□
PRODUCT CHANGE NOTICE
PCN Form (D4-E000-73)

PCN#10-022

TCBT-2R5G+, TCBT-6G+, TCCH-80+

Attachment to PCN#10-022

GU1604

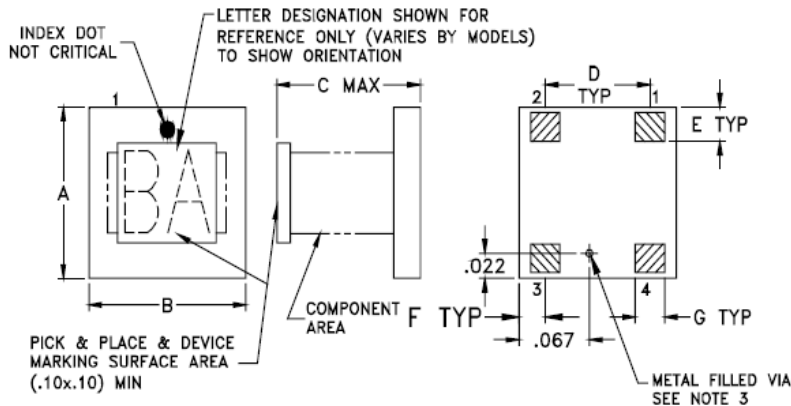
Addition of flat 'lid' to top-side of the core to enhance customer ability to handle in automated processing and to provide a surface for device marking

- No change in overall dimensions specification
- No change in fit , function or part number
- Minor change in form (device appearance and added model specific marking)
